# UNITED STATES PATENT AND TRADEMARK OFFICE

10/591,298

<b>Office Action Summary</b>	<b>Application No.</b> 10/591,298	<b>Applicant(s)</b> WADA ET AL.	
	<b>Examiner</b> JOHN K. KIM	<b>Art Unit</b> 4125

## DETAILED ACTION

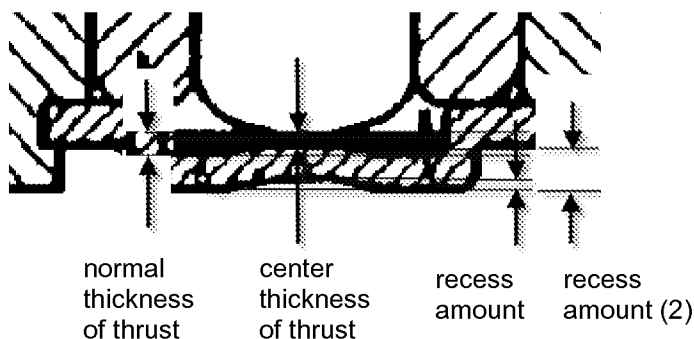
Line 26-29, page 3 recites ".... a thrust sheet which is thinner than a recess amount of the thrust cap is provided between the thrust cap and the shaft". However, Fig. 1 shows the thickness of thrust sheet (even if compared to the thickness at center) is thicker than recess amount (see sketch below). If the 'recess amount' indicates 'recess amount (2)' as shown in sketch below, the thrust sheet can be thinner than the recess amount.

The thickness of thrust sheet mentioned in the same sentence above is not uniform according to Fig. 1. Therefore, it is not clear which portion of the sheet is referred for comparison. The examiner understands the thickness at the center portion is of interest. Appropriate correction is required.

Sketch for claim 5

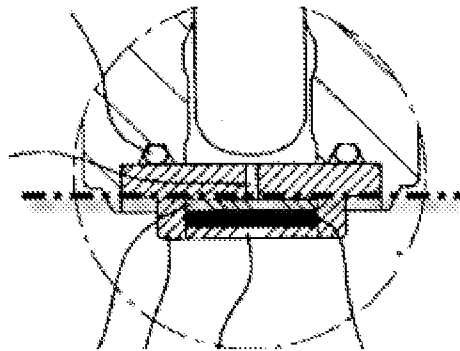
In the same field of endeavor, Kim teaches (in Fig. 3) a lower end surface of cap (16) by recess has the same height as that of a lower end surface of the swaging portion of the cap of holder. (see bold dash line in sketch below)
